DU MONT

SERVICE NOTES

DU MONT TELESETS

RA-105 -- RA-106 SECTION

ANTI-FLICKER CIRCUIT

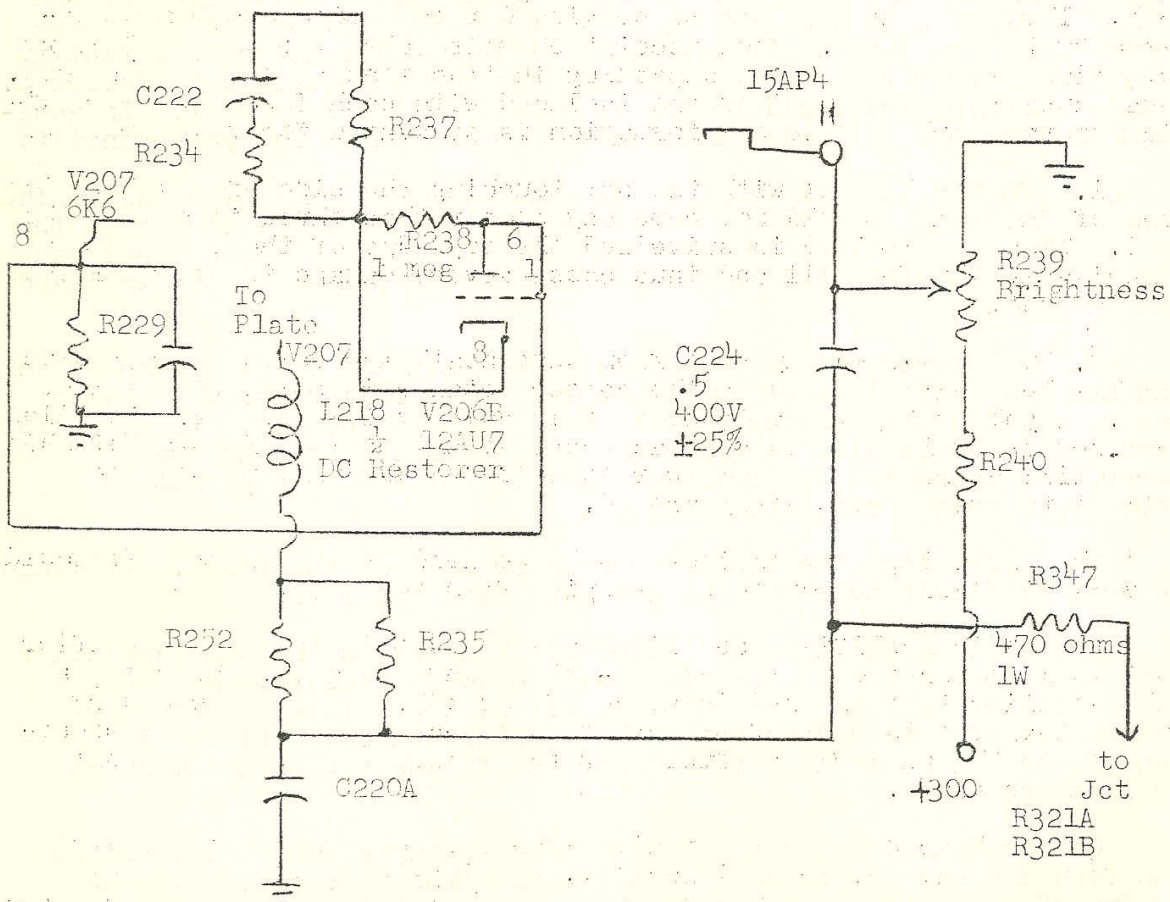
The schematic shown below illustrates changes made in the RA-105, RA-106 main chassis to reduce flicker. The flicker referred to results from periodic line voltage fluctuations such as are produced by reciprocating pumps and like devices. This change is sometimes referred to as an "anti-flicker circuit".

1. Pins #6 and #7 on V206-B the DC restorer tube are removed from ground.
2. Pins #6 and #7 on V206-B are connected together and a lead is run from pin #6 of V206-B to pin #8 of V207, thus returning the DC restorer to the cathode of the third video amplifier instead of ground.
3. Capacitor C224 is changed from .1 200V \pm 25% to .5 400V \pm 25%. The part number of the new capacitor is 03014260.
4. Capacitor C224 is connected between pin #11 of the CRT and the junction of R235 and C220A.
5. Resistor R347 470 ohms 1 W 10% (part #02034730 alternate part #02044730) is connected in series between R232 and R321.

AGC CHANGES

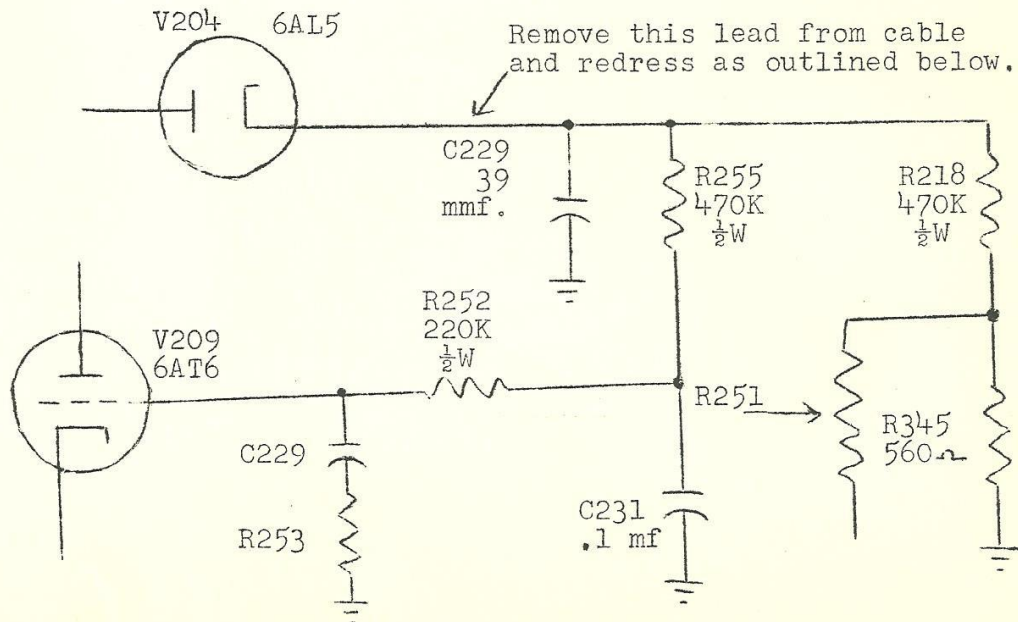
Very humid weather normally encountered in the summer months has been the cause of considerable difficulty with the AGC circuit as used in the early RA-105 Telesets. The condition that is normally encountered was a fading of both picture and sound. When the serviceman checks the set he usually finds that all components are normal and is at a loss to determine the reason for the faulty operation of the receiver. Where this trouble is encountered it is recommended that the following changes in the AGC circuit be made. These changes have been included in production on all of the sets made after March, 1949. The purpose of these changes is to reduce the impedance of the grid circuit of the 6AT6 AGC stage and thus improve the stability of this circuit. The list of changes follow:

R218 was changed from a 1.2 meg. resistor to 470K, $\frac{1}{2}$ W, part number 02032090. It was disconnected from the junction of R252, R255 and C296 and connected to the junction of R345 and R251.

R252 has been changed from a 1.2 meg. resistor to 220K, $\frac{1}{2}$ W, part number 02032050.

R255 and C231 are no longer used.

R345 is changed from a 390 ohm resistor to a 560 ohm $\frac{1}{2}$ watt resistor, part number 02031740.

A 470K, $\frac{1}{2}$ watt resistor, part number 02032090 between pin #5 of V204 and the junction of R252 and C231 was added.

A 39 mmfd. 500 volt ceramic capacitor, part number 03017030 from pin #5 of V204 to ground was added.

C231 was changed from a .005 mfd. capacitor to a .1 mfd. 200 volt capacitor, part number 03013910.

In addition to the above changes the blue lead that runs through the cable from pin #5 of the 6AL5 (V204) to V209 (AGC circuit) should be removed from the cable. This lead should be run as short as possible. A simple method of dressing this is to go through a hole in the RF shield (this shield is the one on which the traps are mounted) to the 6AT6 circuit.

Figure 1

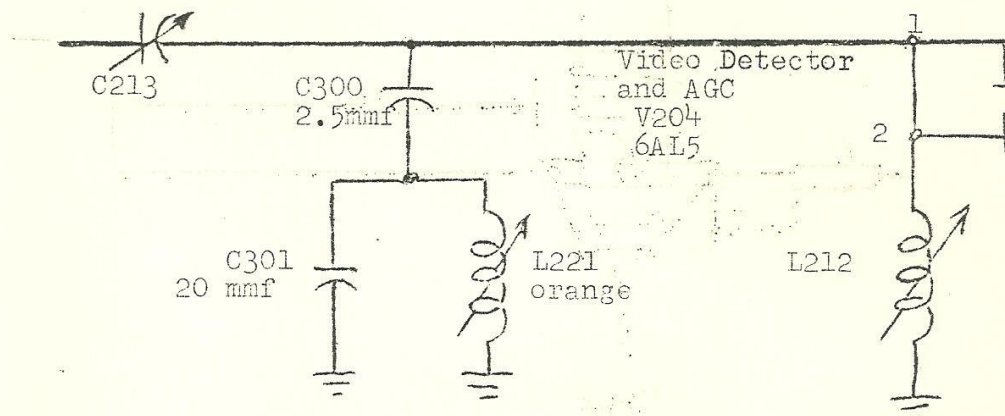
In certain areas where television signals are received on two adjacent channels (such as half way between two cities having television stations) adjacent channel video interference has been observed on RA-105 and RA-106 Telesets. When tuned to the lower frequency channel of two such adjacent channels, interference is usually seen as horizontal sync running back and forth through the desired signal.

This may be corrected in the field by the addition of a series-parallel resonant trap in the third video IF amplifier as illustrated in Fig. 1. (Note: the latest RA-105 and RA-106 Telesets include this trap).

This trap will be tuned to 20.4 mc. This 20.4 mc is obtained when the local oscillator beats with the video carrier of the channel above the desired channel. Consider a location where both channel #5 and channel #6 can be received. With the Teleset tuned to channel #5, 76-82 mc, the local oscillator is tuned to 77.25 mc (video carrier of channel #5) plus 26.4 mc or 103.65 mc. The local oscillator signal also beats with the video carrier of channel #6 (83.25 mc) and produces a frequency equal to the difference between 103.65 mc and 83.25 mc which is 20.4 mc.

Figure 2

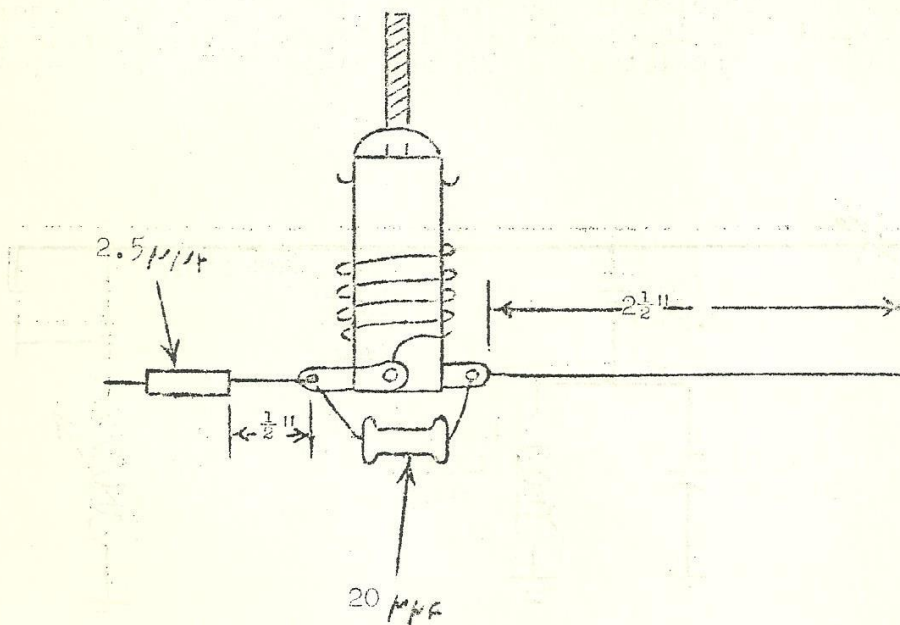
Connect the 2.5 uuf capacitor to the lug to which the end of the winding closest the lug is soldered, leaving $\frac{1}{8}$ " of wire between the body of the capacitor and the lug.

Connect a $2\frac{1}{2}$ " length of #18 bare-tinned copper wire to the other lug of the inductor. Connect the 20 uuf capacitor across both of the lugs of the inductor. See Fig. 2.

Figure 3

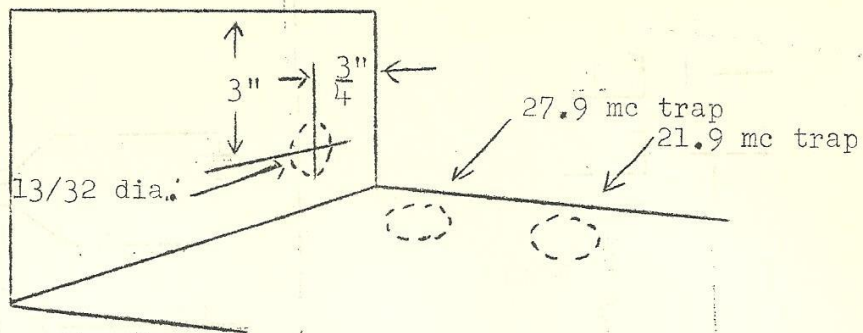
Carefully enlarge the "keyhole", to $\frac{13}{32}$ diameter, in the video IF amplifier shield plate using a Parker-Kalon Metal Punch XII. See Fig. 3.

Use extreme caution when punching this hole so that alignment will not be disturbed.

Insert the trap assembly in the hole so that the lugs are parallel to the main chassis and with the bare wire away from the main chassis. Solder the bare-tinned wire to the ground lug directly beneath on the main chassis. Solder the free end of the 2.5 uuf capacitor to the junction of L212, C213, and Pins 1 and 2 of V204.

RA-106 POWER SUPPLY CHANGE

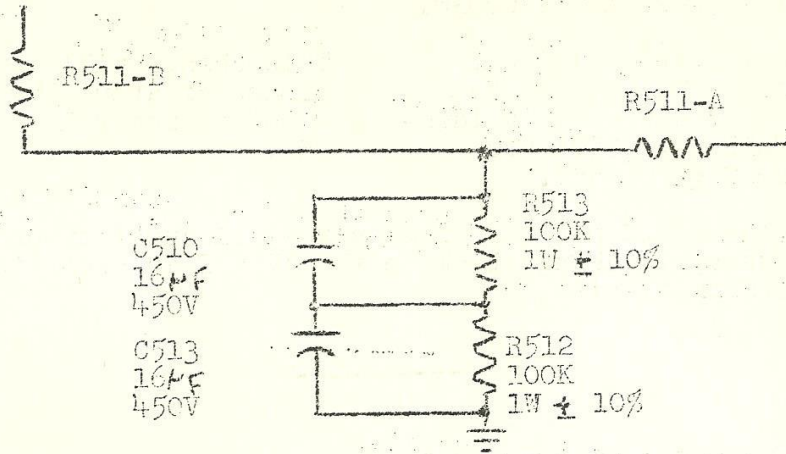
A $\frac{1}{2}$ amp fuse, (Part #11001100) is being added in series with L702 at the junction of R724, C714 and the primary of T701.

The 4 amp fuse F701 was changed to a 5 amp. fuse. The new fuse is described as follows:

The increase in fuse rating was made to prevent accidental fuse burnout.

The schematic of the Main Chassis (dated Nov. 15, 1948) should be corrected as shown in the following sketch:

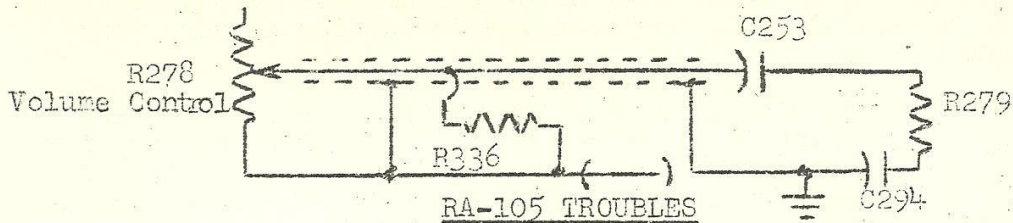
(The error is in the volume control circuit, where R336 is shown shorted out and the "hot" wire of the shielded lead is shown grounded. The sketch shows the correct connections).
